**1.2 1221-1249 CENTRE ROAD, OAKLEIGH SOUTH
USE AND DEVELOPMENT OF THE LAND FOR PRELOADING OF EARTH AND
CONSTRUCTION OF BUILDINGS AND WORKS (TEMPORARY LANDFILL GAS
VENTING TRENCH) AND ALTERATION OF ACCESS TO A TRANSPORT ZONE, 2
(TPA/53179)**

EXECUTIVE SUMMARY:

This application proposes further remediation and rehabilitation works on the site of the former Talbot Road Quarry. Ground improvement works (pre-loading) and a temporary landfill gas venting trench are proposed in the north west corner of the site.

LEGEND	
	INFERRED PIT BATTER (APPROX.)
	FINAL SITE LEVEL (APPROX.)
	STOCKPILE FILL LEVEL
	EXISTING GROUND LEVEL

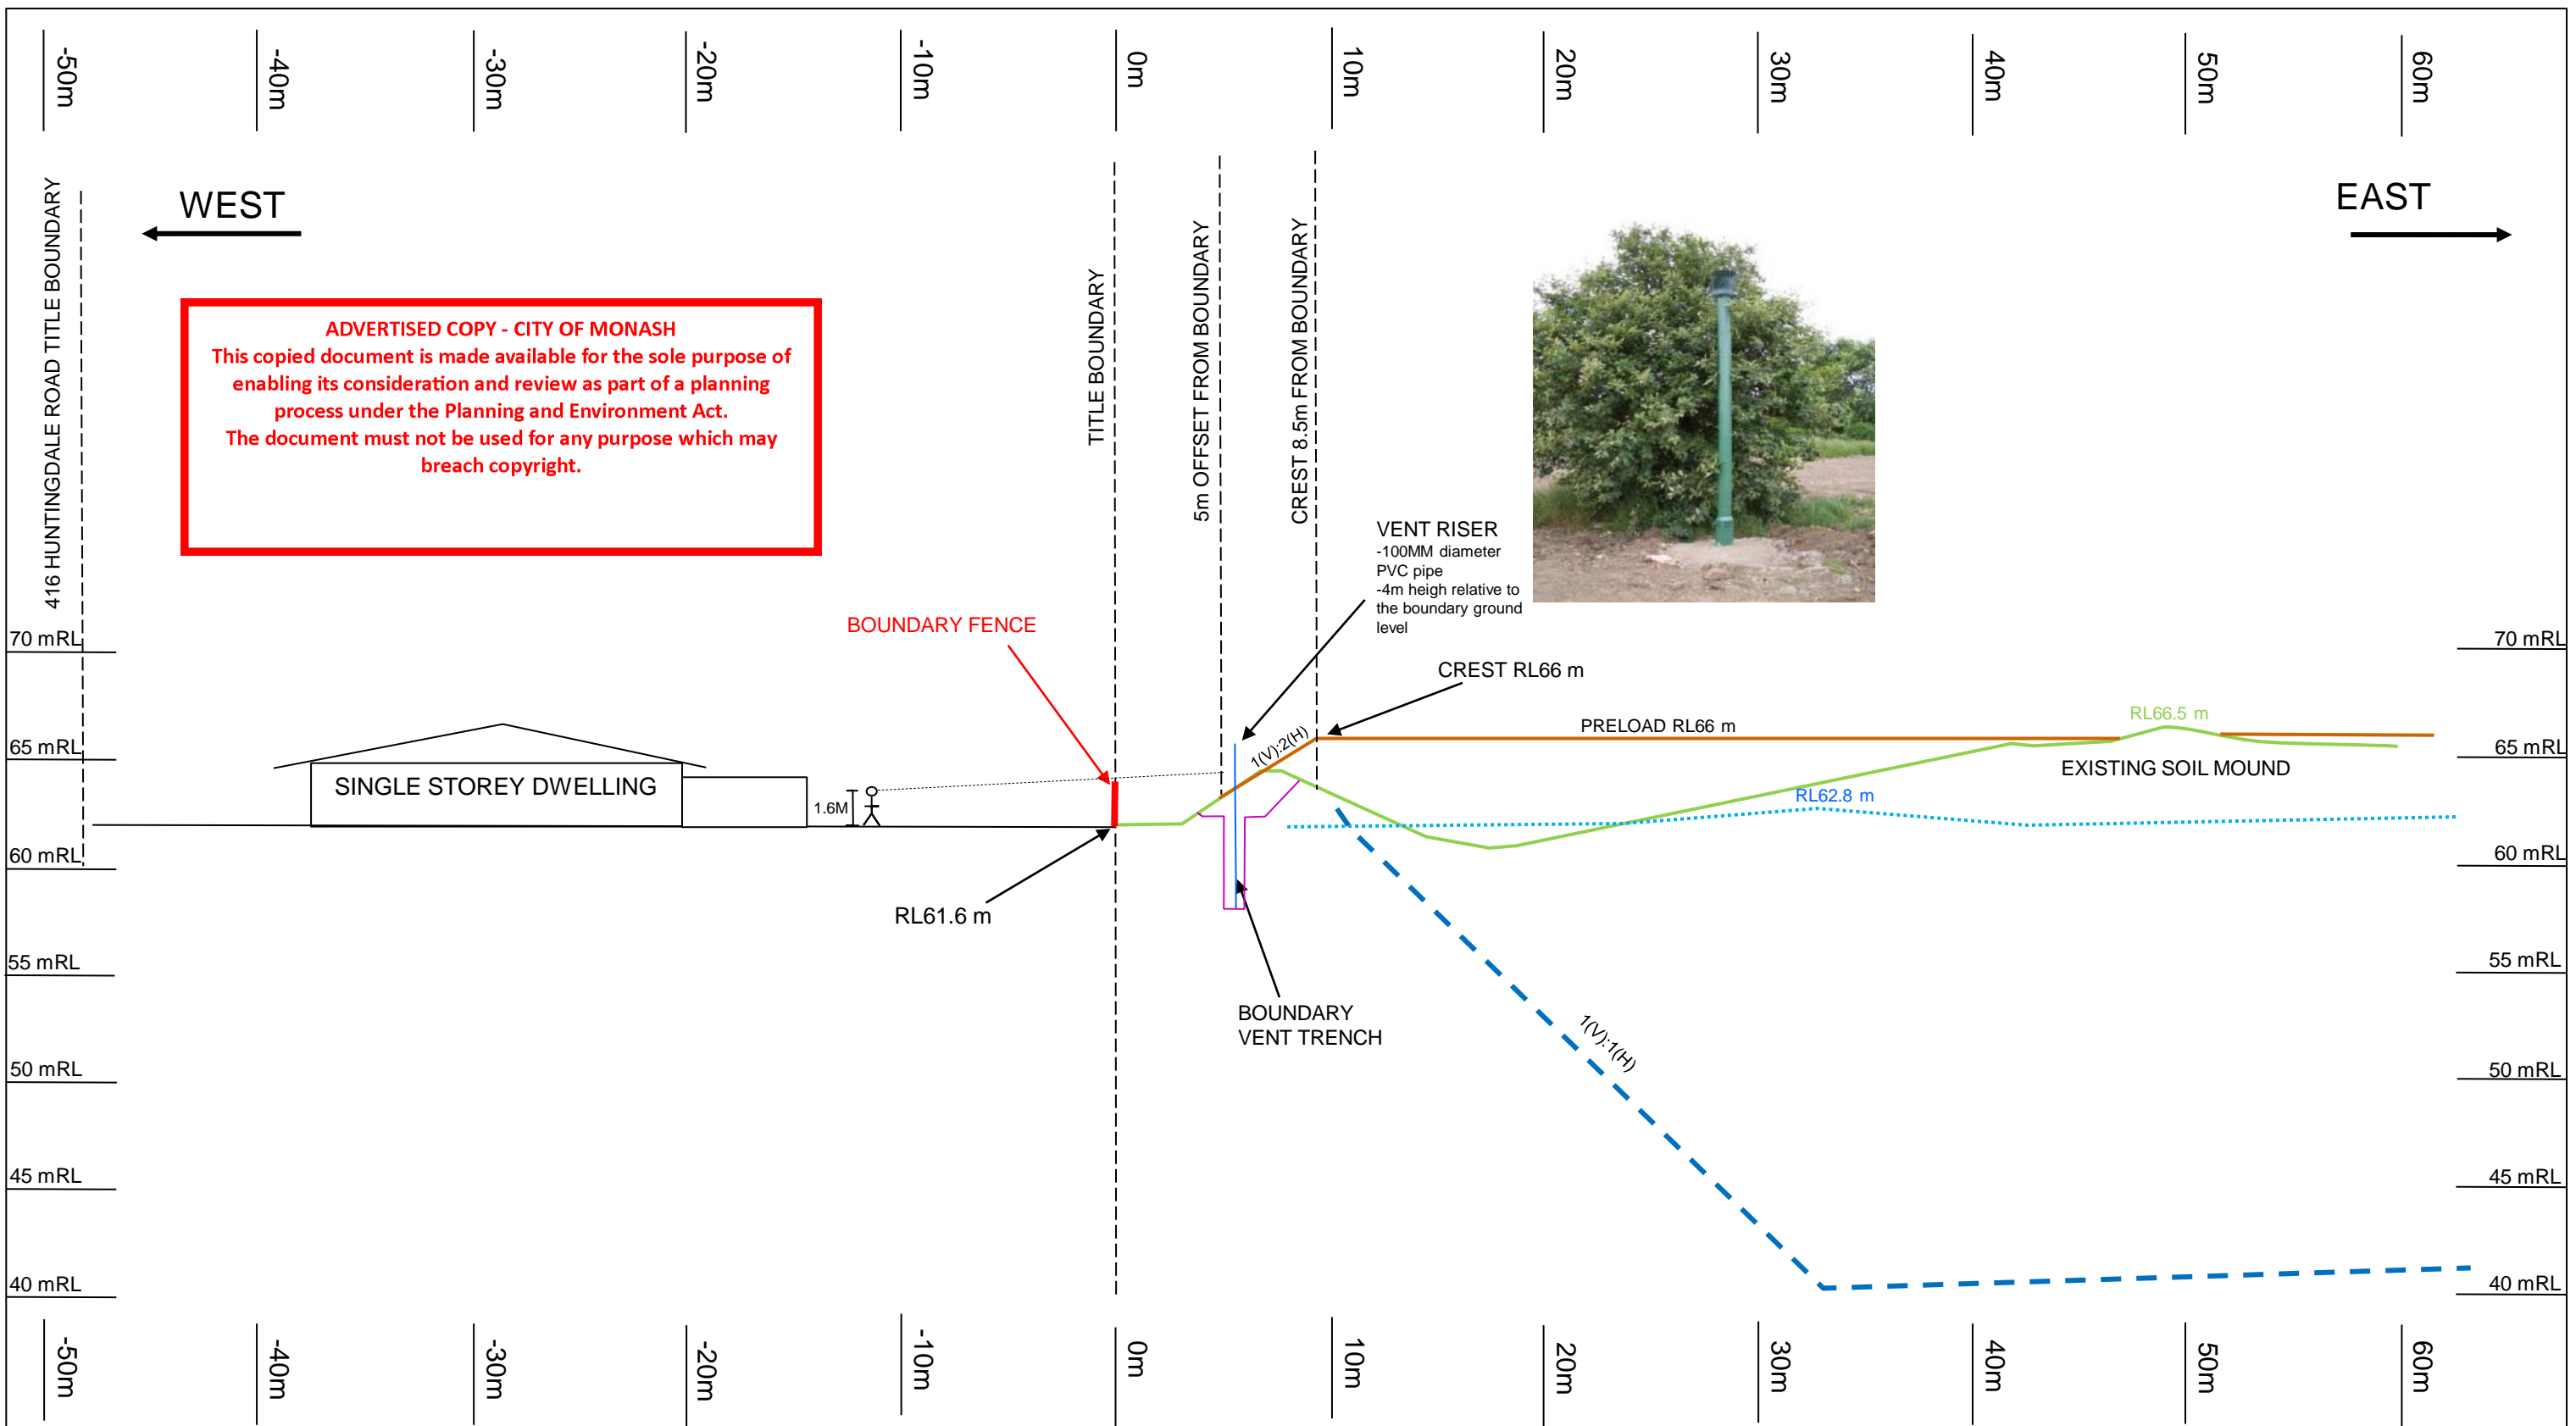
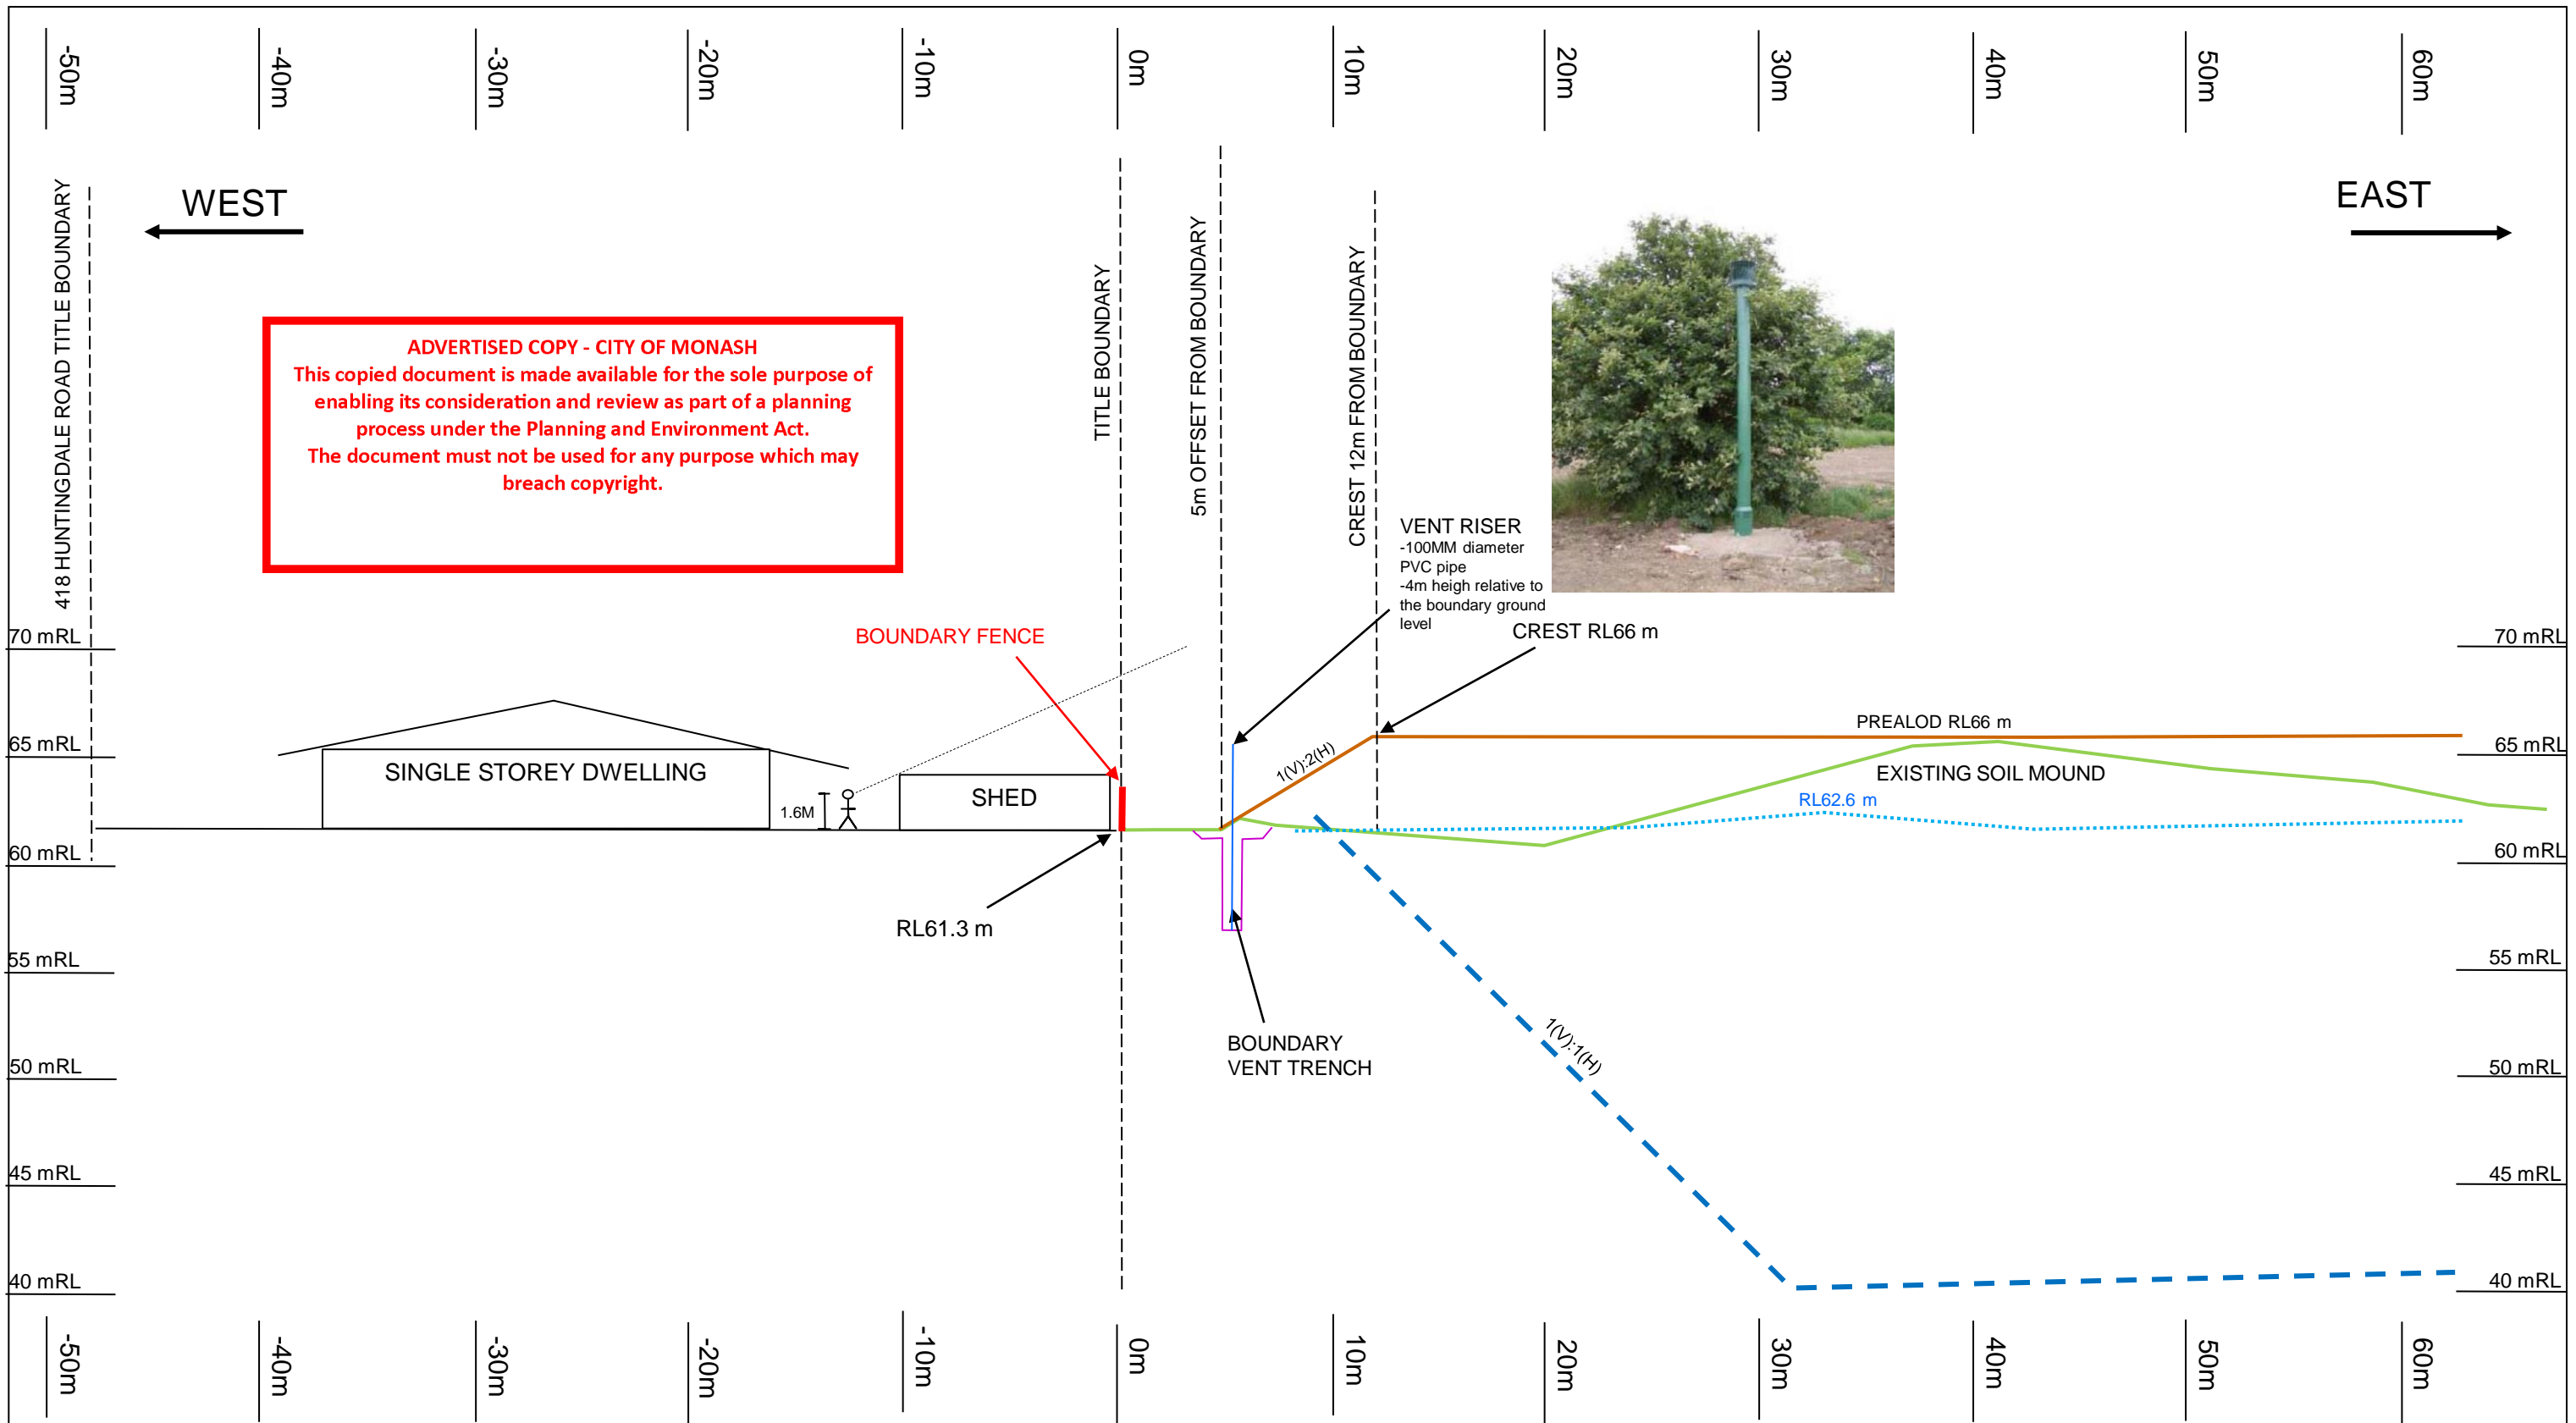
- a) The location and height of the proposed silt fencing to be shown on sectional diagrams prepared by Tetra Tech Coffey.
 - b) The location and minimum setbacks of the proposed swale drain to adjoining properties and identified on sectional diagrams on the plans prepared by Tetra Tech Coffey.

- Concern is raised with the slope of the batter in relation to the proximity of the boundaries and the interface with the residential properties. This will need to provide for a more gradual and gentle slope.

- The preload has been designed with a 5m buffer from the site boundary to the toe of preload batter. This enables the crest/top of the preload to extend to the edge of the pit crest to provide a uniform surcharge over the landfill to reduce subsequent total and differential settlement of the landfill capping layer and structural fill layers.
